CLARK
BARNES

MINOR REVISION: ADDITIONAL STORY

8403 GREENWOOD AVE NORTH

PROJECT #:3025261

NORTH 84TH STREET: MASSING STUDY

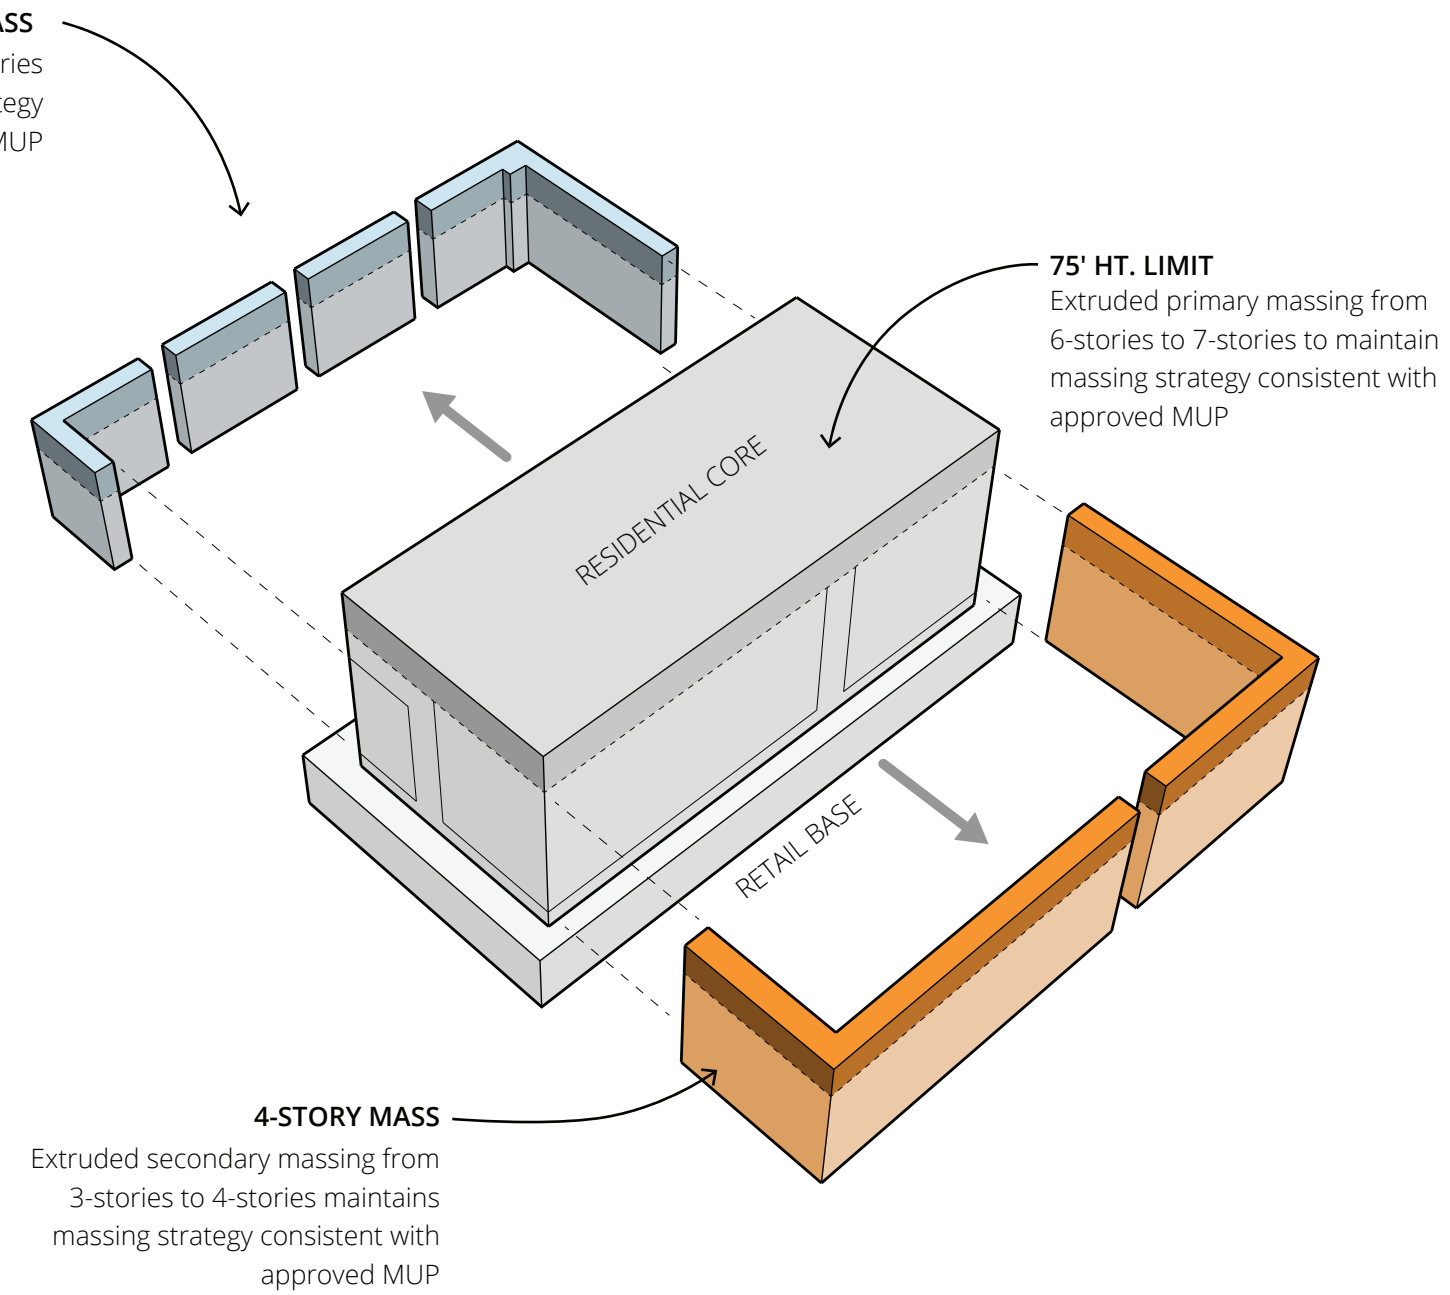
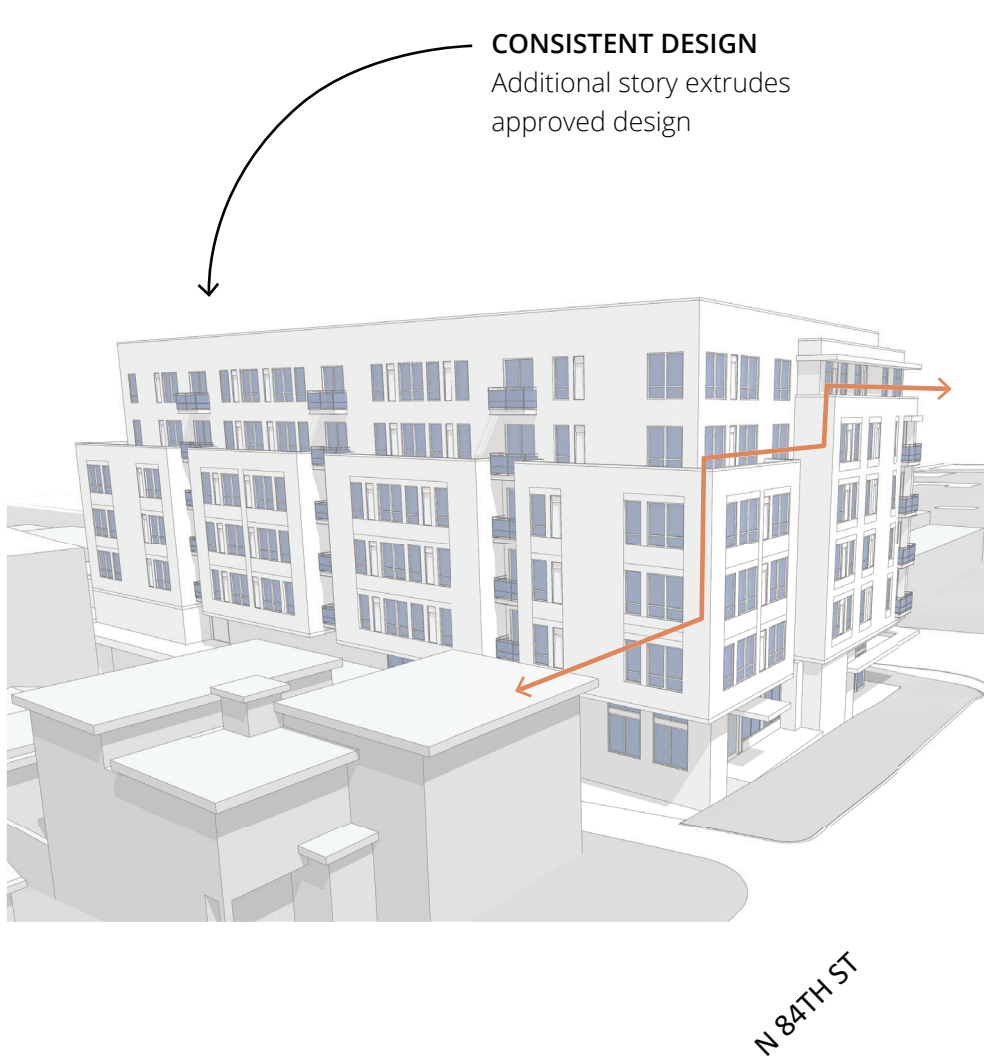
Preferred strategy extrudes the approved MUP massing 1 story and requires upper level setback (23.47A.014.C) departure along North 84th Street and Greenwood Avenue North.

CONSISTENT DESIGN
Additional story extrudes approved design

NORTH 84TH STREET: PROPOSED

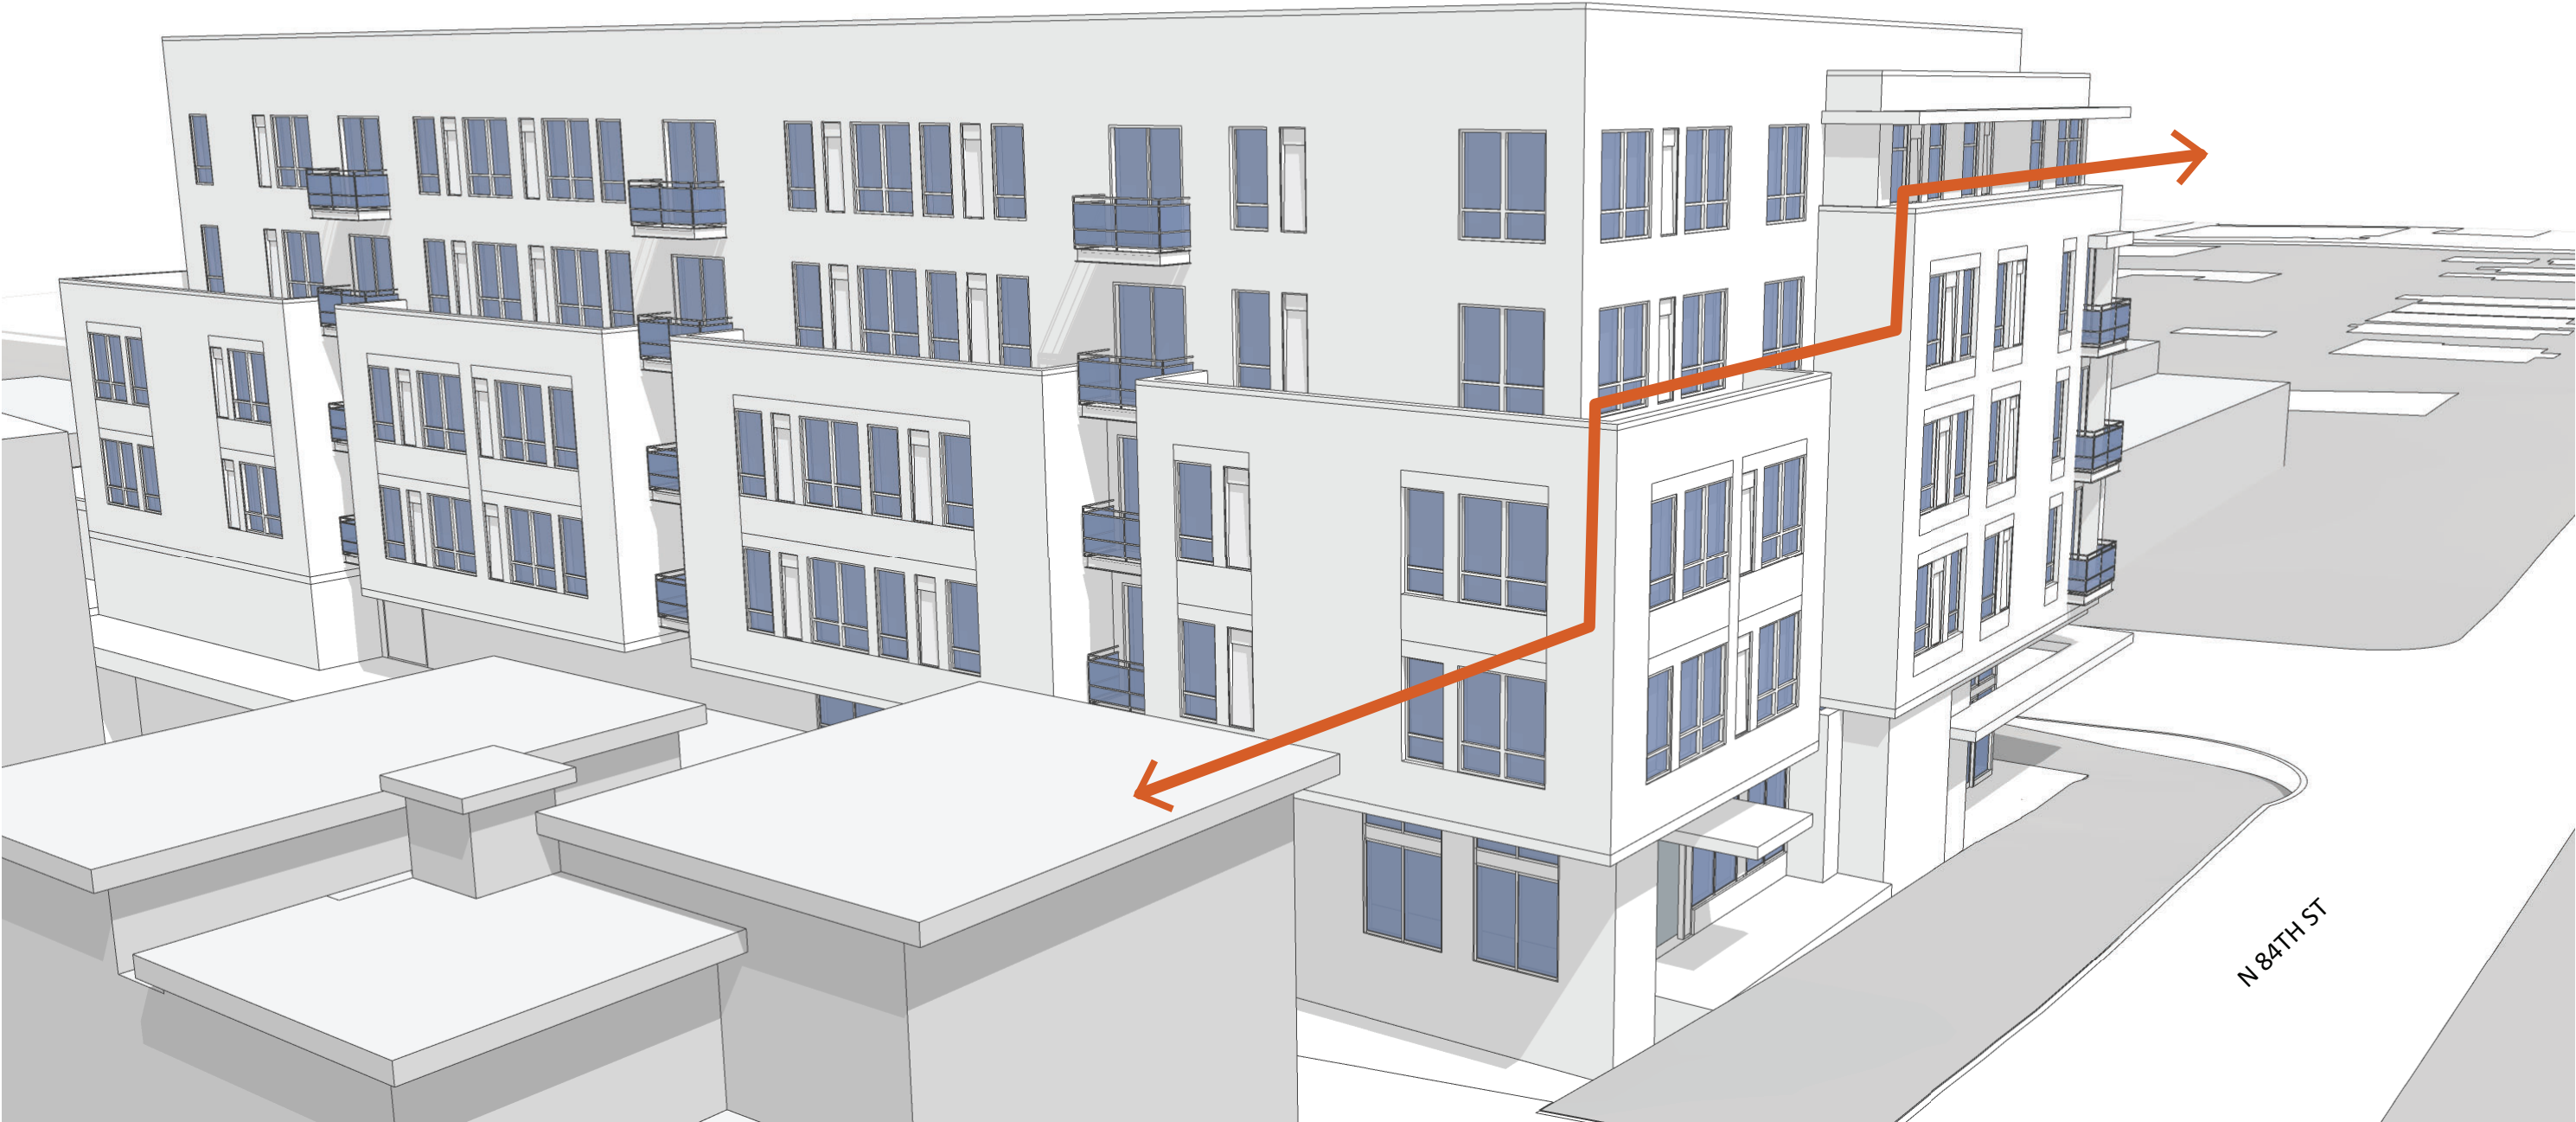
Preferred strategy extrudes the approved MUP massing 1 story and requires upper level setback (23.47A.014.C) departure along North 84th Street and Greenwood Avenue North.

GREENWOOD AVENUE NORTH: MASSING STUDY

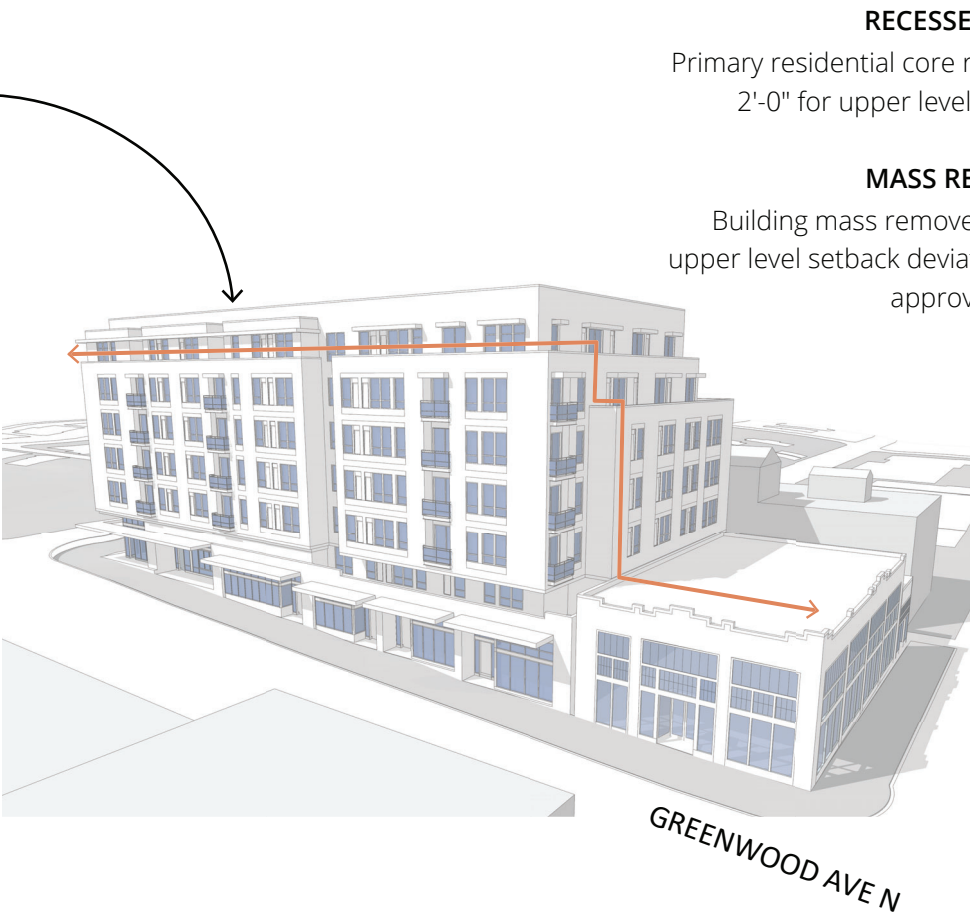
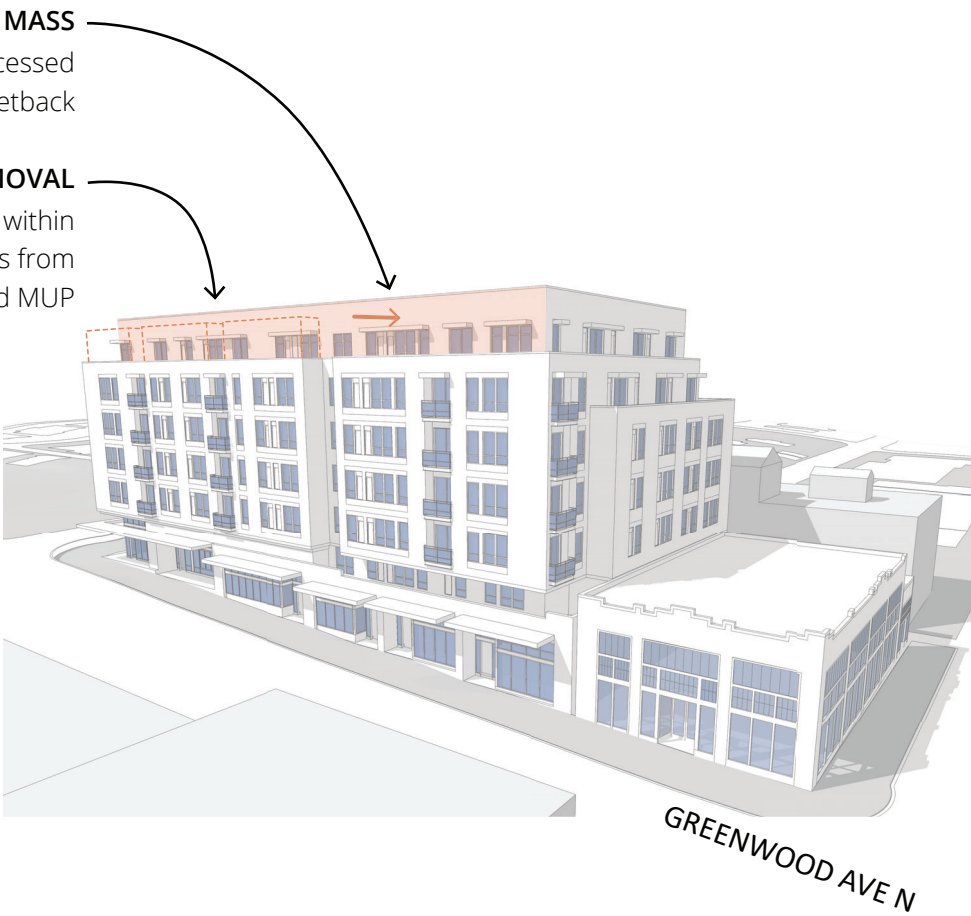
Preferred strategy extrudes the approved MUP massing 1 story and requires upper level setback (23.47A.014.C) departure along North 84th Street and Greenwood Avenue North.

DEPARTURE #1: UPPER-LEVEL SETBACK | GREENWOOD AVE N

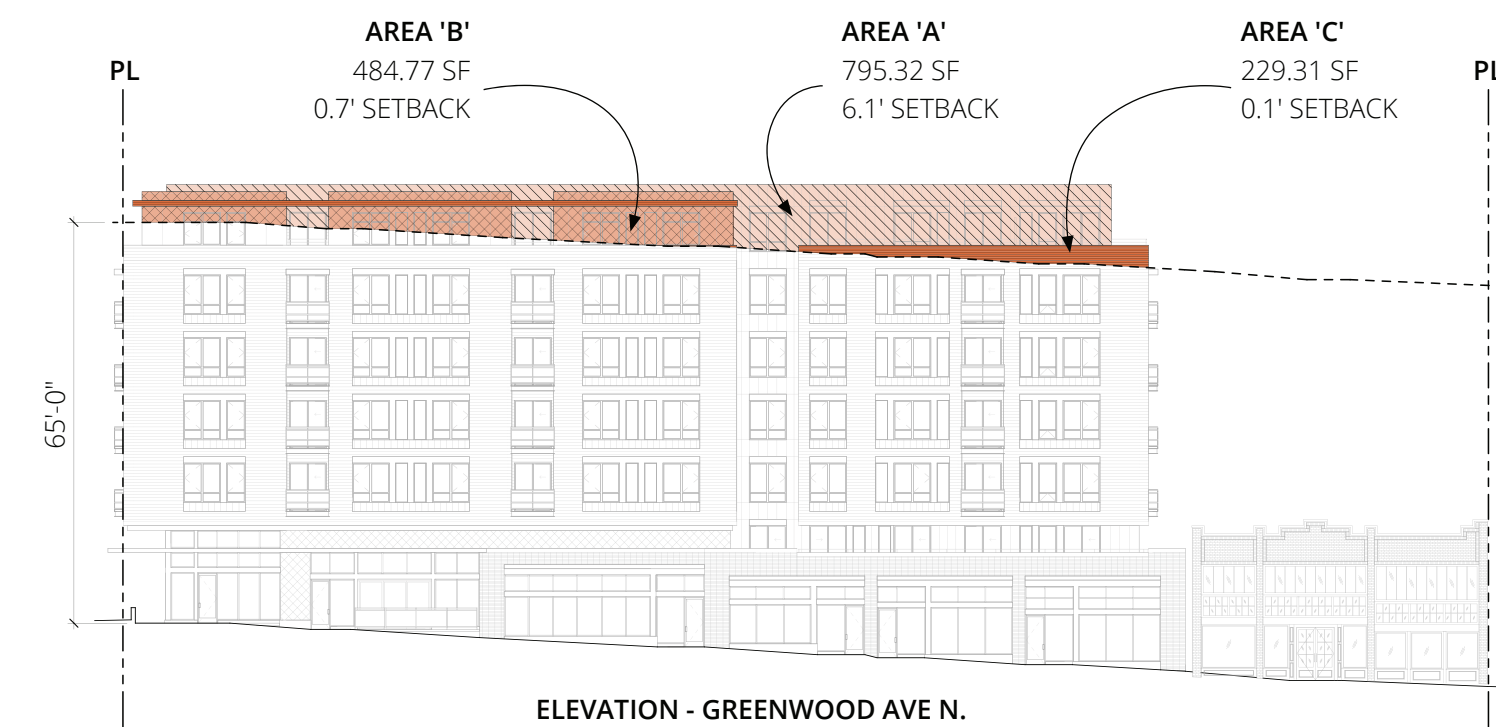
- 1. Portions of structures above 65' must be set back from the front lot line by an average depth of 8'.
- 3. No more than 20% of the portion of the structure that must be set back may have a setback of less than 5'.

- 1. Portion of structures above 65' must be set back from the front lot line by an average depth of 3.45'.
- 3. No more than 47.31% of the portion of the structure that must be set back may have a setback of less than 5'.

The project has opted into MHA by adding Level 7. Our proposal provides a design consistent with the approved MUP, by extruding the inter-locked massing strategy to level 7. The original design intent and upper floor articulation will be lost if the massing is fully recessed to be compliant with the upper level setbacks.

Wall Face	Area SF	Setback Depth	Calculation
A	795.32	6.1	(795.32 x 6.1) = 4,851.45
B	484.77	0.7	(484.77 x 0.7) = 339.34
C	229.31	0.1	(229.31 x 0.1) = 22.93
TOTAL	1,509.40	3.45 AVG.	5,213.72 / 1,509.40

Average Setback Depth = 3.45'

Portion of structure set back less than 5' = 47.31% (714.08 / 1,509.40 = 47.31%)

DEPARTURE #2: UPPER-LEVEL SETBACK | N. 84TH ST.

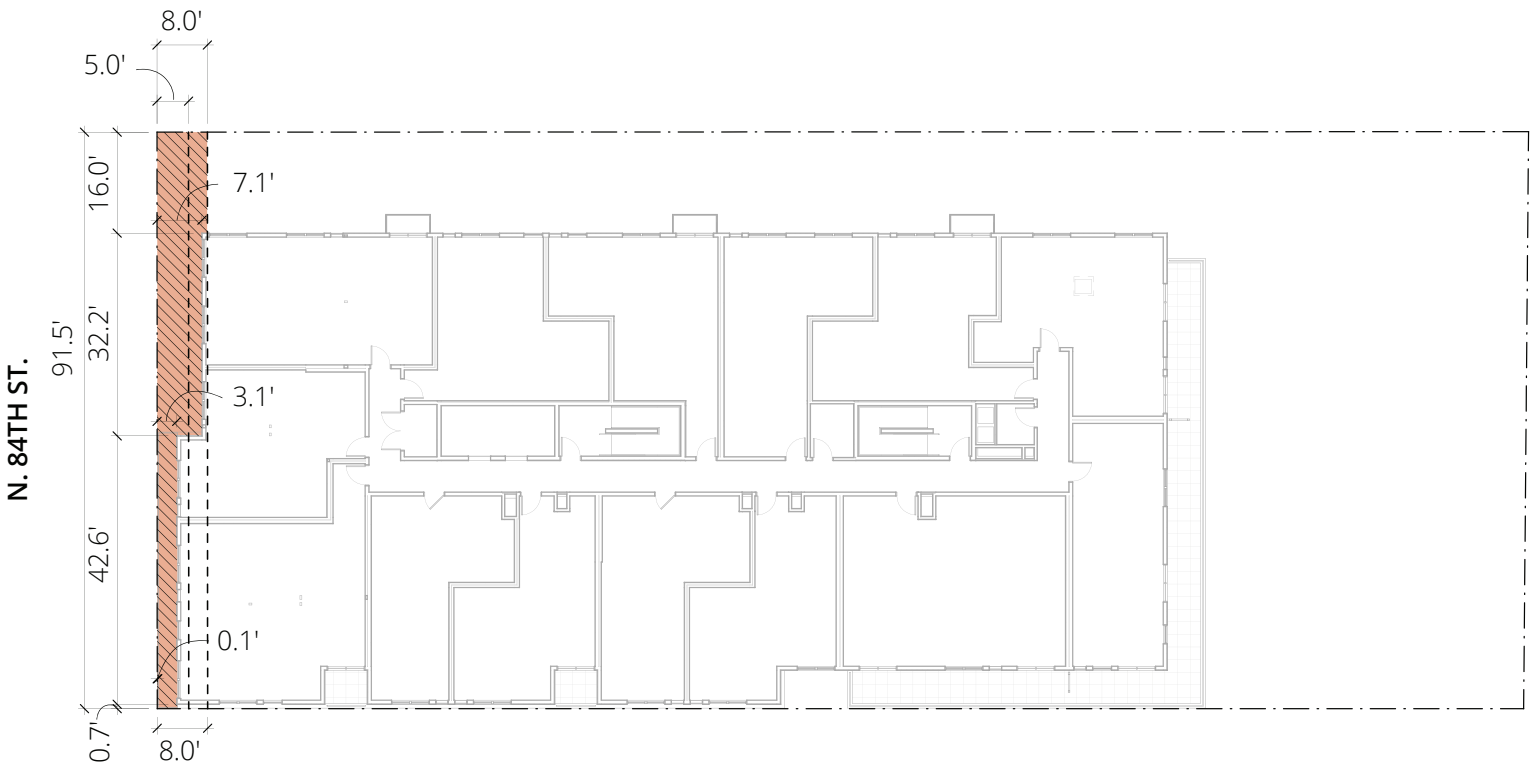
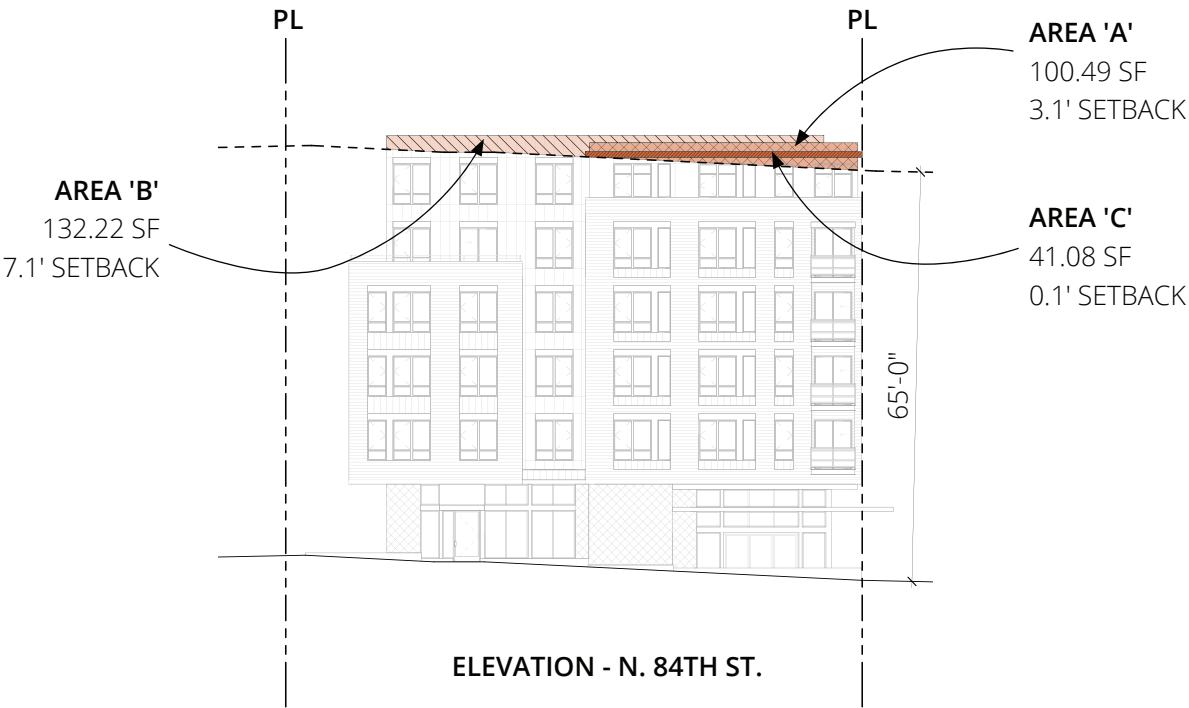
- 1. Portions of structures above 65' must be set back from the front lot line by an average depth of 8'.
- 3. No more than 20% of the portion of the structure that must be set back may have a setback of less than 5'.

- 1. Portion of structures above 65' must be set back from the front lot line by an average depth of 4.58'.
- 3. No more than 51.71% of the portion of the structure that must be set back may have a setback of less than 5'.

The project has opted into MHA by adding Level 7. Our proposal provides a design consistent with the approved MUP, by extruding the inter-locked massing strategy to level 7. The original design intent and upper floor articulation will be lost if the massing is fully recessed to be compliant with the upper level setbacks.

Wall Face	Area SF	Setback Depth	Calculation
A	100.49	3.1	(100.49 x 3.1) = 311.52
B	132.22	7.1	(132.22 x 7.1) = 938.76
C	41.08	0.1	(41.08 x 0.1) = 4.11
TOTAL	273.79	4.58 AVG.	1,254.39 / 273.79

Average Setback Depth = 3.45'

Portion of structure set back less than 5' = 51.71% (141.57 / 273.79 = 51.71%)
